## Product Change Notice (PCN)

**PCN Number:** PCN-0454852R-01

SJ2-35954A-SMT-TR, SJ2-35954B-SMT-TR, SJ2-35954D-SMT-TR

Reason(s) for Change: *Manufacturing process improvements*

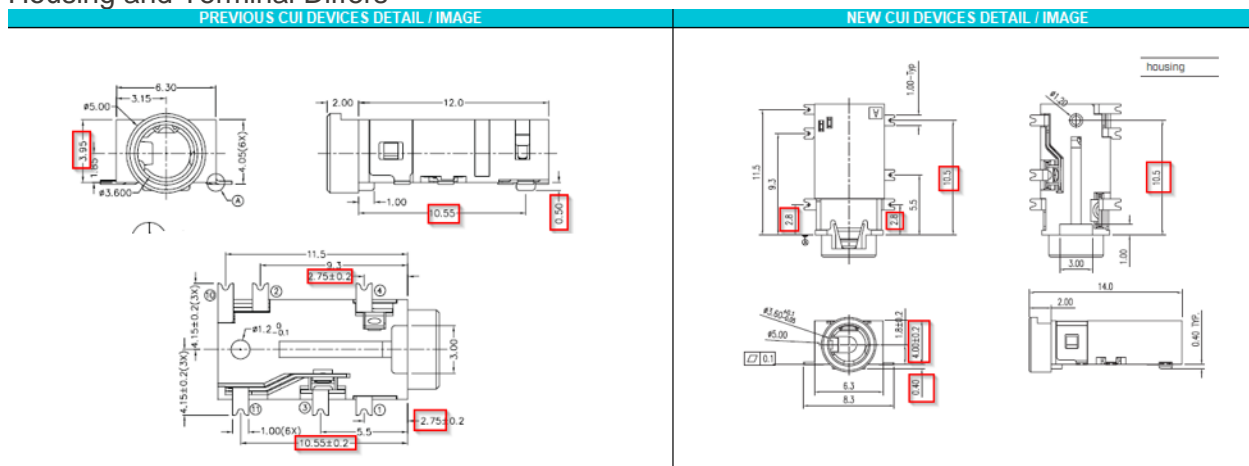
- Housing and Terminal Differs

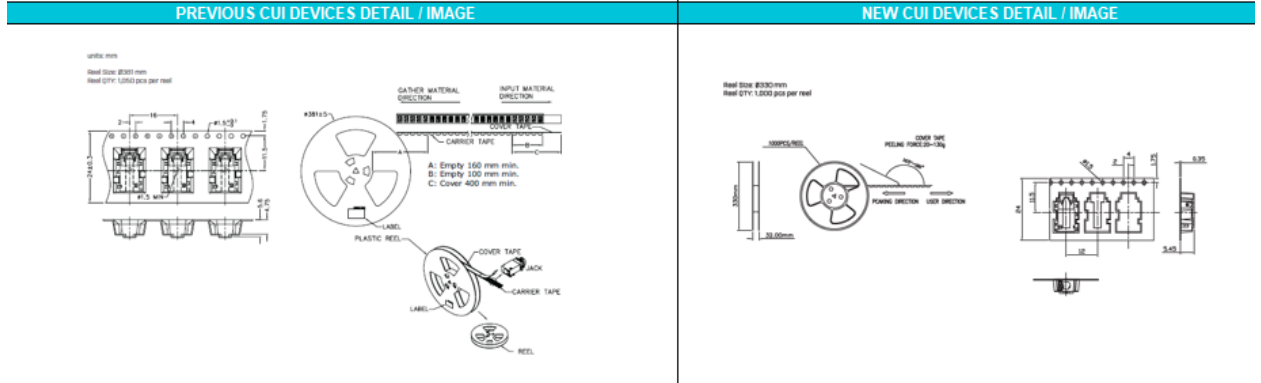
## 4. Reflow Soldering Difference

PREVIOUS CUI DEVICES DETAIL / IMAGE	NEW CUI DEVICES DETAIL / IMAGE																																										
<b>SOLDERABILITY</b>	<table border="1"> <thead> <tr> <th>parameter</th> <th>conditions/description</th> <th>min</th> <th>typ</th> <th>max</th> <th>units</th> </tr> </thead> <tbody> <tr> <td>refl storage</td> <td>at relative humidity &lt;80%</td> <td></td> <td>40</td> <td></td> <td>°C</td> </tr> <tr> <td>reflow soldering<sup>1</sup></td> <td>see reflow profile</td> <td>255</td> <td>260</td> <td>265</td> <td>°C</td> </tr> <tr> <td>drying conditions<sup>2</sup></td> <td>parts in reel: bake at 40°C ±5°C for 72 hours parts removed from reel: bake at 40°C ±5°C for 10 hours</td> <td></td> <td></td> <td></td> <td></td> </tr> </tbody> </table> <p>Note: 3. Must reflow solder within 72 hours from opening vacuum packaging at a temperature &lt;30°C &amp; relative humidity &lt;60%. 4. When exceeding floor life by &gt;10 hours.</p>	parameter	conditions/description	min	typ	max	units	refl storage	at relative humidity <80%		40		°C	reflow soldering <sup>1</sup>	see reflow profile	255	260	265	°C	drying conditions <sup>2</sup>	parts in reel: bake at 40°C ±5°C for 72 hours parts removed from reel: bake at 40°C ±5°C for 10 hours					<table border="1"> <thead> <tr> <th>parameter</th> <th>conditions/description</th> <th>min</th> <th>typ</th> <th>max</th> <th>units</th> </tr> </thead> <tbody> <tr> <td>refl storage</td> <td>5-25°C, 20-75% humidity</td> <td></td> <td>40</td> <td></td> <td>°C</td> </tr> <tr> <td>reflow soldering</td> <td>see reflow profile</td> <td>255</td> <td>260</td> <td></td> <td>°C</td> </tr> </tbody> </table> <p>Note: 1. CUI Devices recommends usage of the product within 24 hours after TSS is opened. After 24 hours, CUI Devices recommends drying the parts prior to use.</p>	parameter	conditions/description	min	typ	max	units	refl storage	5-25°C, 20-75% humidity		40		°C	reflow soldering	see reflow profile	255	260		°C
